UNITED STATES PATENT AND TRADEMARK OFFICE

APPLICATION NO.	FILING DATE	FIRST NAMED INVENTOR	ATTORNEY DOCKET NO.	CONFIRMATION NO.
10/730,406	12/08/2003	Darrell J. Atwood	169-PA-0103	2479

Office Action Summary	Application No. 10/730,406	Applicant(s) ATWOOD, DARRELL J.	
	Examiner Timothy M. Ayres	Art Unit 3637

DETAILED ACTION

Ingalls '529 Figure 2

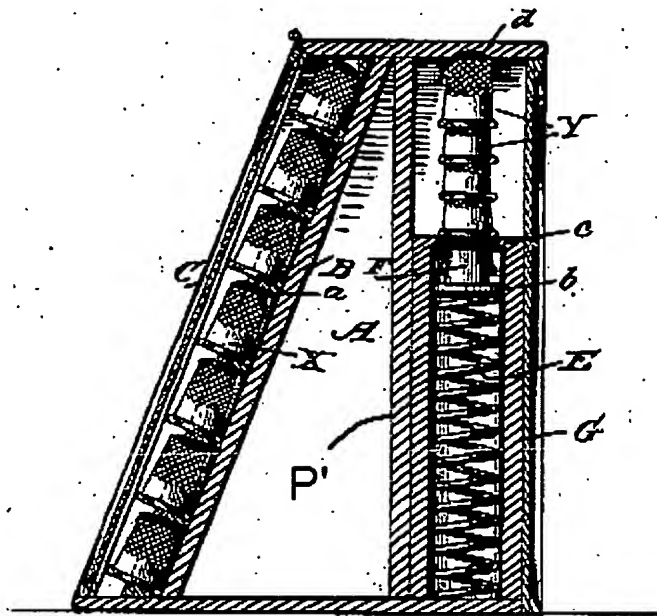
13. Claims 1-3, 11, 12, 16, and 17 rejected under 35 U.S.C. 102(b) as being anticipated by US Patent 764,529 to Ingalls. Ingalls teaches a display case with a case body (A) made up of a base member, a lid member (d), a rear panel (G), and an observation panel (C) with a glass window. A compartment panel (P') divides the case into a front compartment with goods (X) and a rear compartment with goods (Y). A display shelf (B) with a display stop (a) is sloped so that it extends from the base to an upper edge of the compartment panel. The display shelf (B) extends across the width of the observation panel. The glass observation panel (C) is pivotally about the lid, which makes it removable. The base member and the lid member are parallel, which makes

them capable of being stacked. The rear compartment has support ledge (c) to elevate goods (Y). Goods (X, Y) are disclosed as thimbles though inherently can be a model-packaging box. Therefor the support ledge (c) is the means for suspending the model-packaging box.

House '747 Figure 1

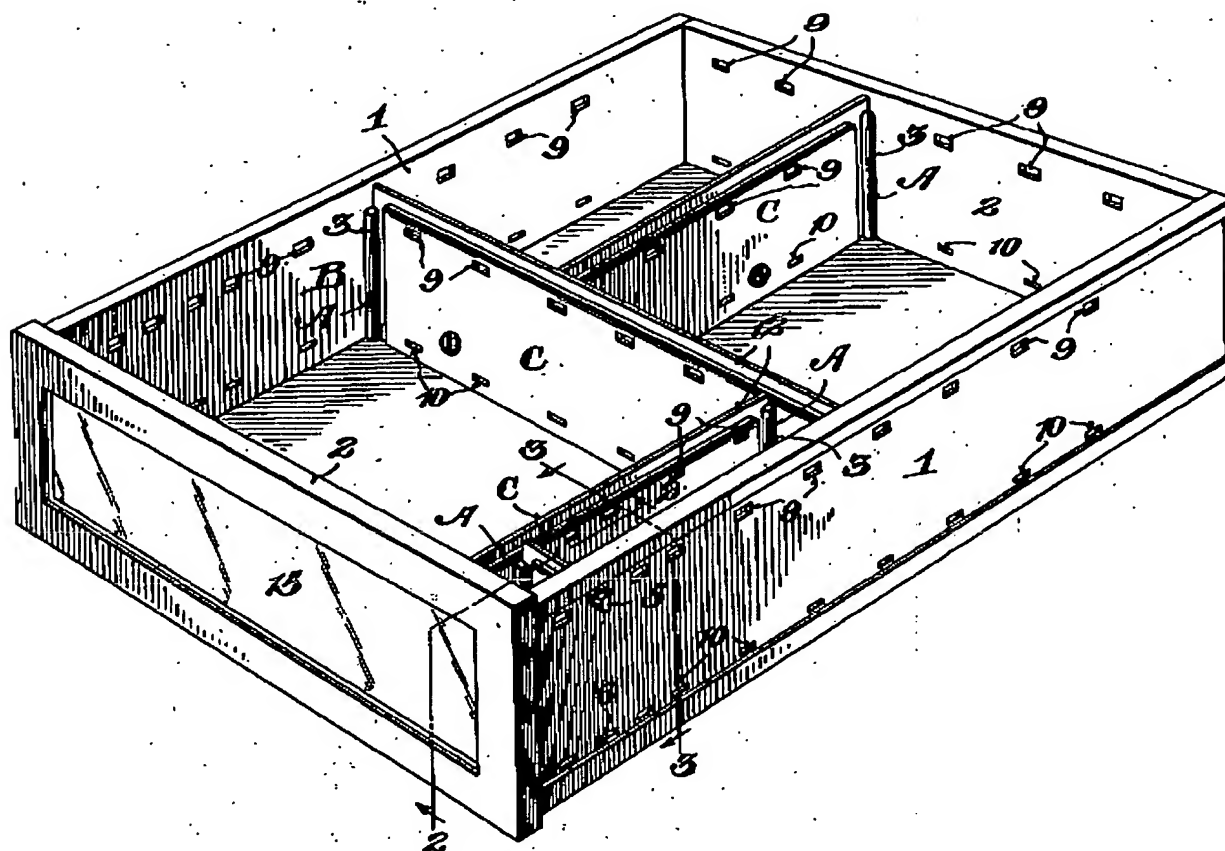
17. Claim 6 is rejected under 35 U.S.C. 103(a) as being unpatentable over US Patent 764,529 to Ingalls in view of US Patent 6,722,747 to House. Ingalls discloses every element as claimed and discussed above except the compartment panel is a mirror panel. House teaches using a mirror panel (4) to be able to see the underside of a car in a display housing (1). At the time of the invention it would have been obvious for a person of ordinary skill in the art to modify the compartment panel of Ingalls by making it a mirrored surface as taught by House to see the other side of the object without having to remove the object (House '747, col. 1, lines 28-30).

Medford '558 Figure 1

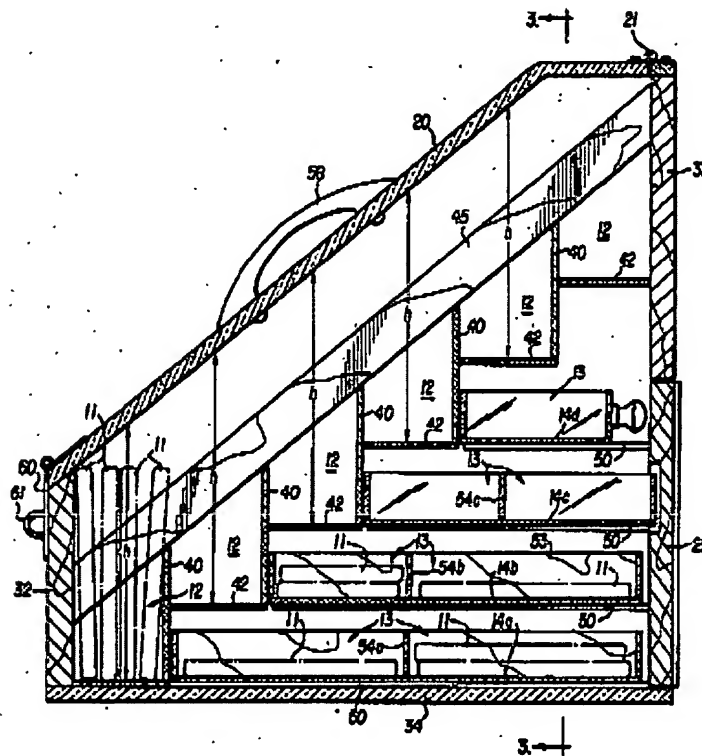
20. Claim 15 is rejected under 35 U.S.C. 103(a) as being unpatentable over US Patent 764,529 to Ingalls in view of US Patent 4,285,558 to Medford. Ingalls discloses every element as claimed and discussed above except the lid member is pivotally attached. Medford discloses a display case with a lid (20) that is pivotally attached at hinge (21). At the time of the invention it would have been obvious for a person of

ordinary skill in the art to take the display case of Ingalls and use the teaching of Medford to add a rotatably lid to allow greater access to the compartments.
